The CDRC was unable to make the findings for a design review recommendation of approval based on certain design deficiencies. In order to resolve these deficiencies in the project's design, a more thorough review of the "Standards for Design for One-Family and Two-Family Residential Development in the "Midcoast" manual is required. As such, requirements from the CDRC for further project redesign are as follows:

Summary of Changes shown on Page G-550

SITE PLAN COMPARISON

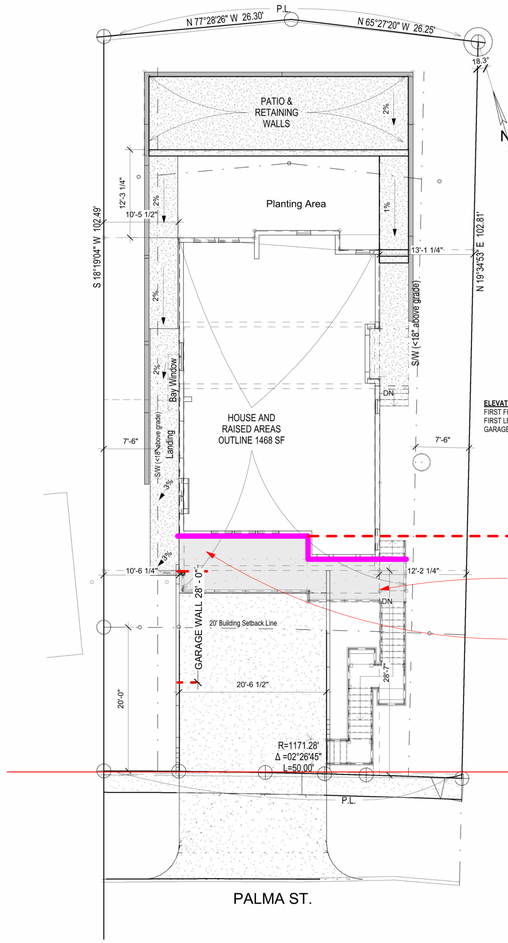
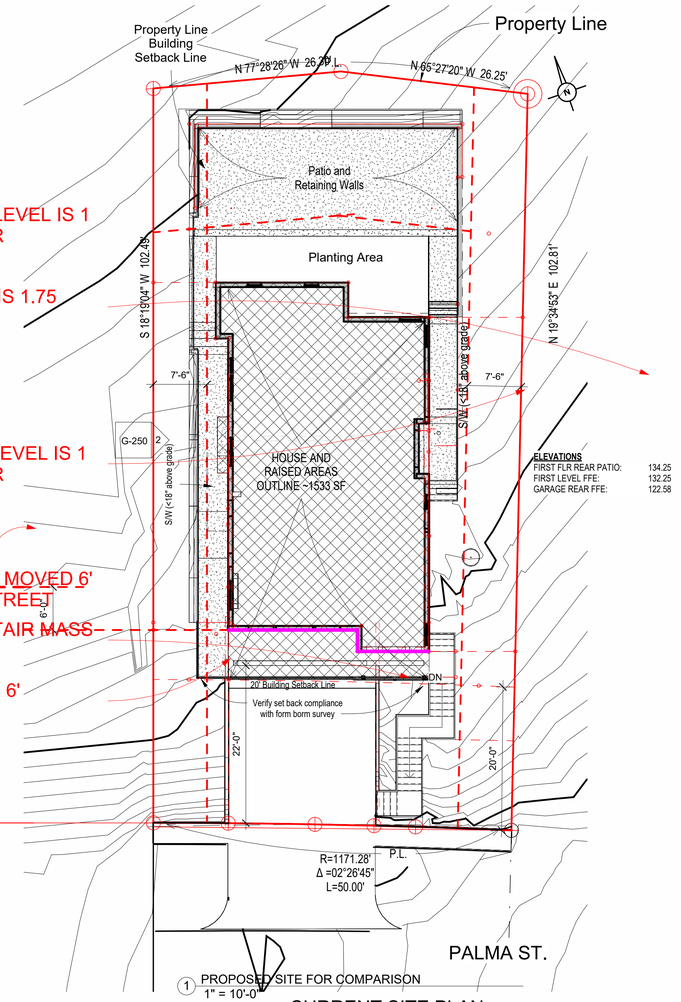
a. **Per Section 6565.20(C). Site Planning and Structure Placement; 1. Integrate Structures with the Natural Setting; b. Grading. (p5). Blend home into site and reduce height and apparent mass. Utilize Consider options such as decreasing the plate height of the garage and moving the lower level (and possibly upper levels) of the structure closer to the street to minimize retaining walls and lower overall apparent height. The house can follow the slope of the driveway design when it moves forward, which not only reduces grading, but also lowers the house and reduces visual mass to address the other Standards. Review the language in the Grading Standards items 1-5 as this issue is clearly addressed.**

1. Relationship to Existing Topography (p10). Per Section 6565.20(D) Element of Design;
   2. Architectural Styles and Features; c. Entries (p16). Revise the layout of the exterior stairs to create a more compact siting footprint. Less stairs are required once the house moves forward and lower, which requires less treads. The addition of oversized landings in the revised design does not decrease the visual aspect of the railings. Consider a switchback stair in both horizontal and vertical orientations to accommodate circulation from the driveway to the house. Moving

Response from Architect: Page A-050 and General reference SITE PLAN COMPARISON page G-250 show that the house has been moved 6 feet forward on the lot. Page A-500 and General reference GRADE SECTION COMPARISON page G-550 show that the house top roof ridge has been initially dropped by 5'-10", and then dropped an additional 8 inches to be 21 inches below the 28' offset requirement. Additionally, page G-550 shows that although the house core has been moved forward by 6 feet, portions of the mass of the house has been shifted back by between 2'-6" and 5'-9", reducing the apparent mass of the outcropping of the house versus the original topography.

the entry of the house down to, or towards, the garage level can also reduce cost, grading and redundant circulation while also creating more stepped massing to follow the topography. Page A-050 and General reference SITE PLAN COMPARISON page G-250 show that after the house has been moved 6 feet forward on the lot, the required stair risers are reduced from 24 to 20, and the extended landings have been removed.

EXTERIOR STAIR MASS REDUCED

DRIVEWAY IS 6' SHORTER

GRADE SECTION COMPARISON

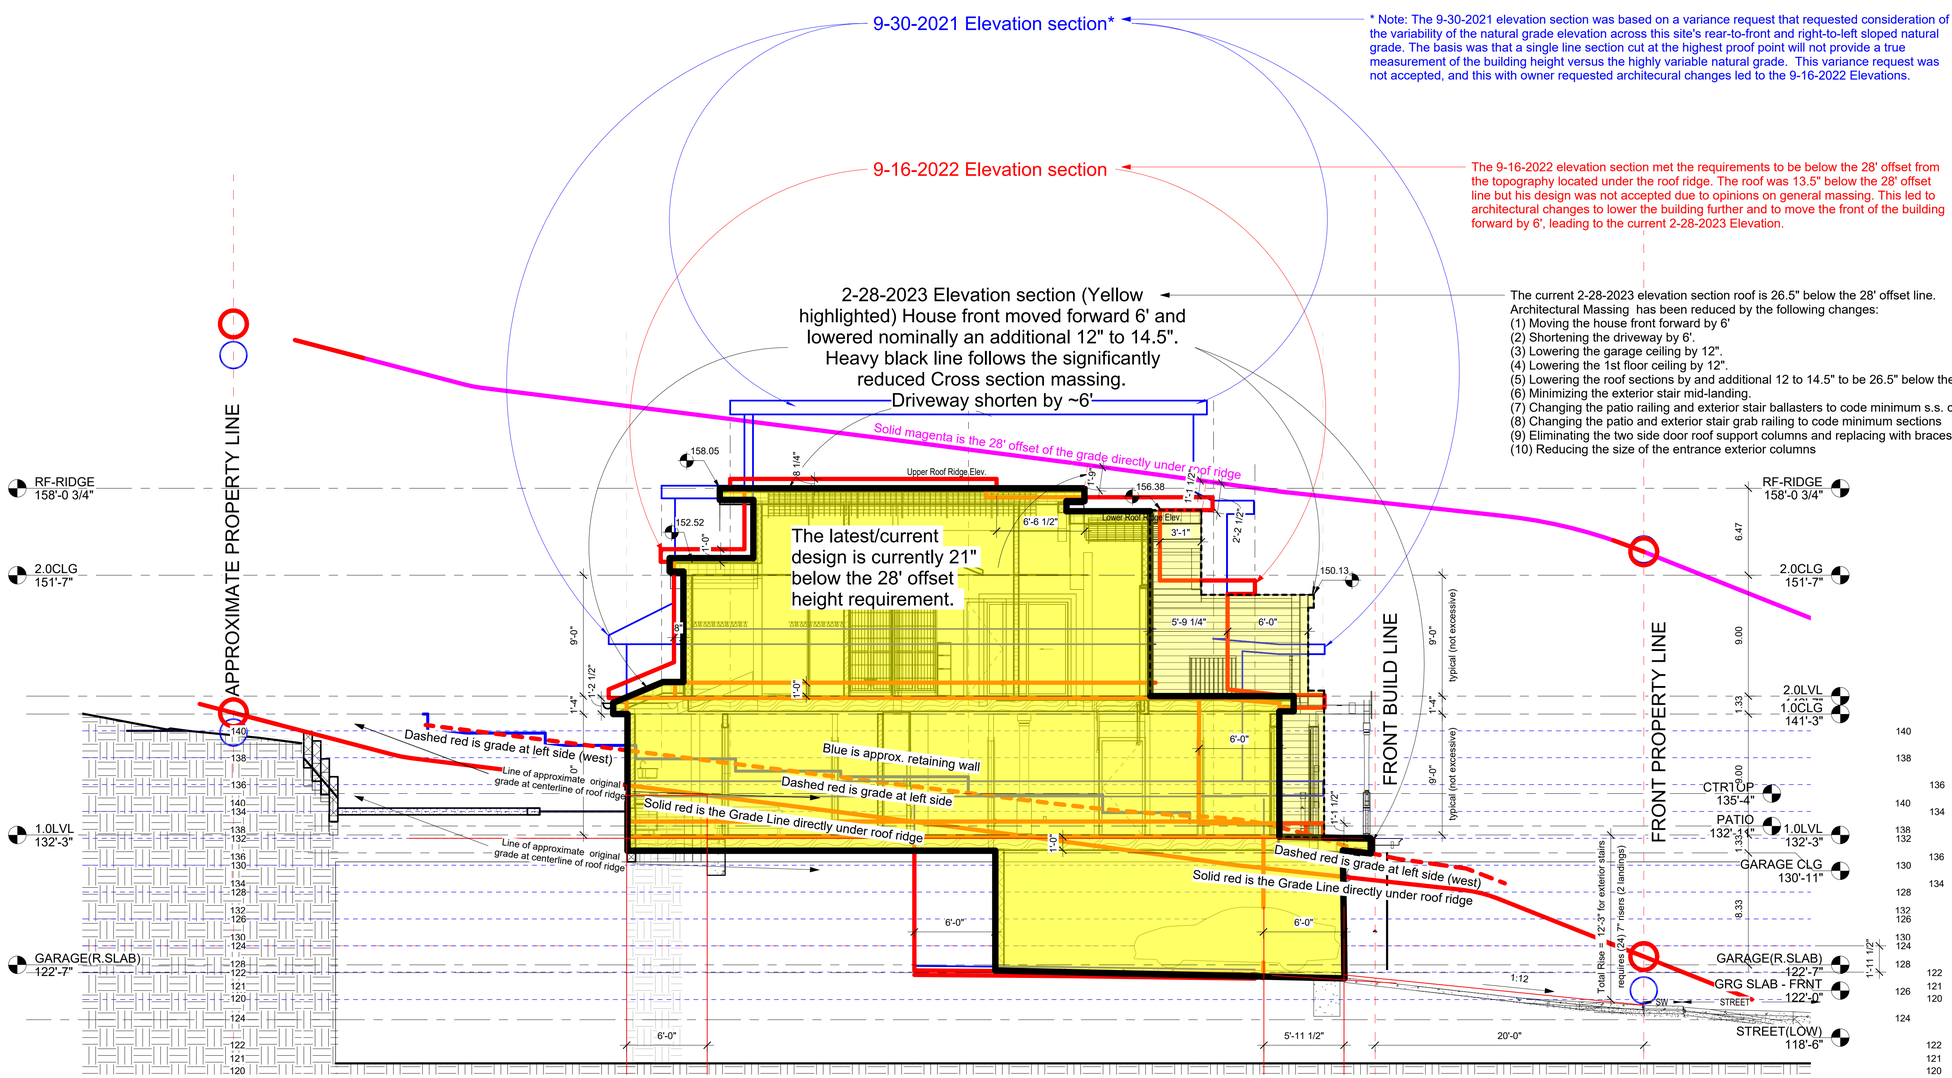
a. Relationship to Existing Topography (p11). Reduce apparent mass and scale by stepping the house up the existing grade to conform with the existing topography of the site. This can be achieved by Consider off-setting each story to step up the natural grade, as mentioned above. Consider large volumes of space and how they can be reduced to add to the stepping, such as the double height Entry and internal stair massing. Stepping the landscaping and paths does not sufficiently offset the mass and scale of the building.

As stated above in response to item a, page G-550 shows that although the house core has been moved forward by 6 feet, portions of the mass of the house has been shifted back by between 2'-6" and 5'-9", reducing the apparent mass of the outcropping of the house versus the original topography.

Note referencing Page G-550 Blue 9-30-2021 Section Outline: The 9-30-2021 elevation section was based on a variance request that requested consideration of the variability of the natural grade elevation across this site's rear-to-front and right-to-left sloped natural grade. The basis was that a single line section cut at the highest proof point will not provide a true measurement of the building height versus the highly variable natural grade. This variance request was not accepted, and this with owner requested architectural changes led to the 9-16-2022 Elevations.

SHEET NAME
SITE PLAN

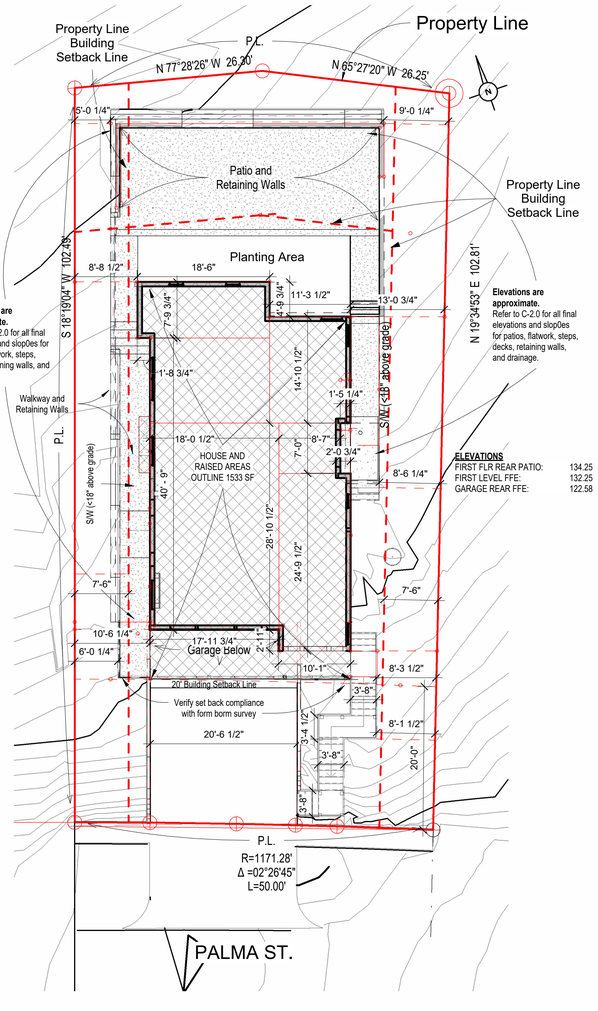
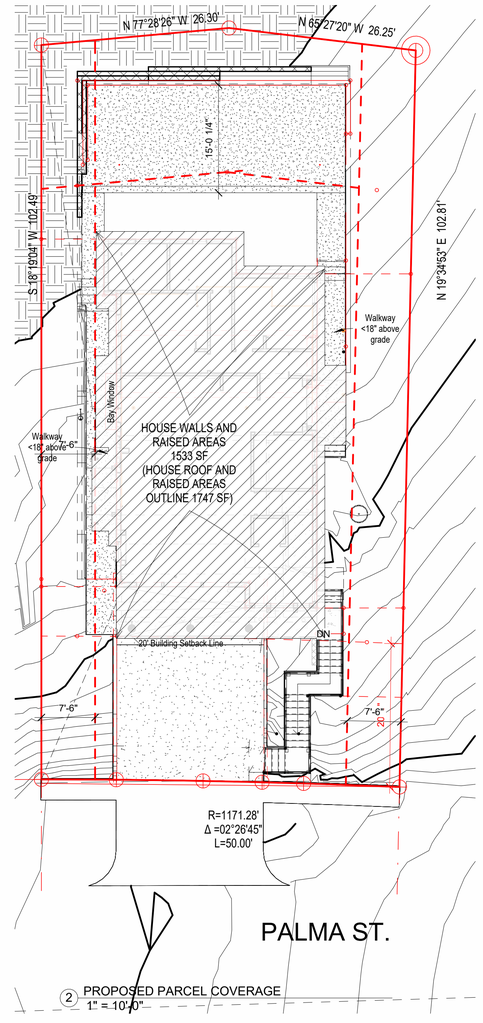
e. Area Plans still are not clearly delineating lot coverage areas and floor areas. The room areas are not relevant to the CDRC review. Provide (2) separate area diagrams to demonstrate lot coverage and floor area, with each area rectangle dimensioned for verification and tabulated in a schedule to show the totals. Be sure to include the garage level and clearly show the extent of the floor area.

Pages A-050 SITE PLAN, contain the Allowable Parcel Coverage calculations (5311 x 0.35 = 1858.85 SF), and the Allowable Building Floor Area calculation (5311 x 0.53 = 2814.83 SF). Below this is a SITE / PARCEL table listing the areas of each level. The total of the areas is 2764 SF which is less than the allowable 2814.83 SF. New Page A-250 'GROSS AREA PLANS WITH WALLS', and revised page Page A-200 'DETAILED AREA PLANS', in addition to providing individual (architectural) room areas repeats the 'APPROXIMATE BUILDING TOTALS (INCLUDING ALL INTERIOR AND EXTERIOR WALLS)' calculation also resulting in 2764 SF, plus defines uncovered patio areas as general architectural information.

BASEMENT/1ST FLOOR PLANS

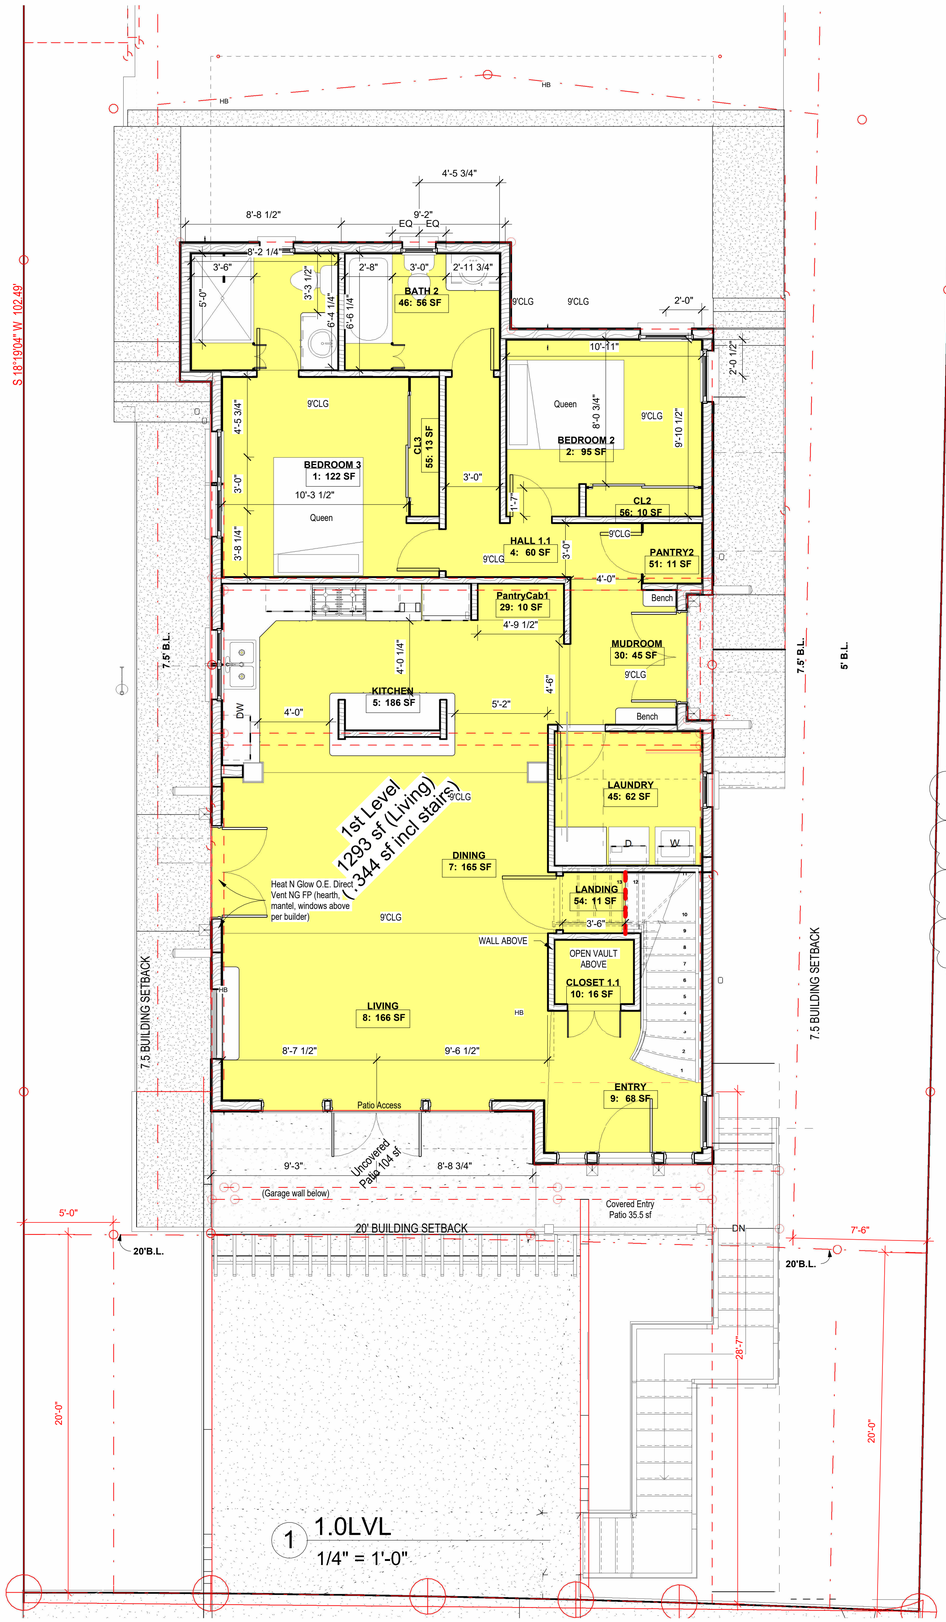
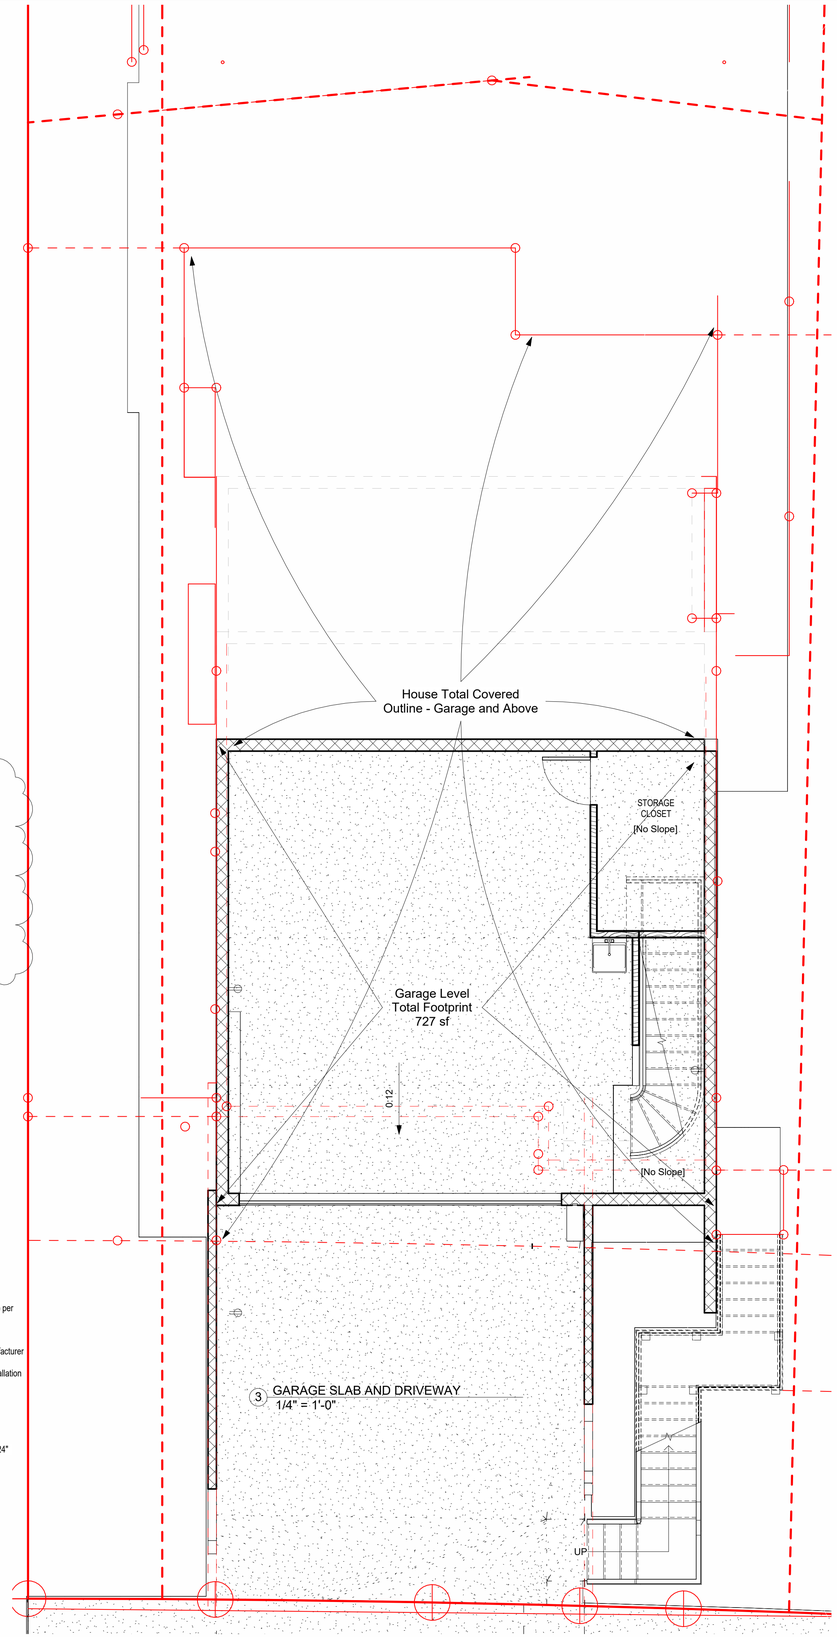
e. Wall Articulation (pp13-14). Reduce apparent mass and scale by stepping in the sides of the building on the second floor. This is also a Standard that has not been met for Second Story Location, Section 6565.20(D)1.c.

As stated above in response to item a and b, although the house core has been moved forward by 6 feet, the added wall articulation shown on pages A-100 and A-150 (also see General reference page G-250) causes those portions of the mass of the house to be shifted back by between 2'-6" and 5'-9". The apparent mass of the outcropping of the house is reduced versus the original topography.
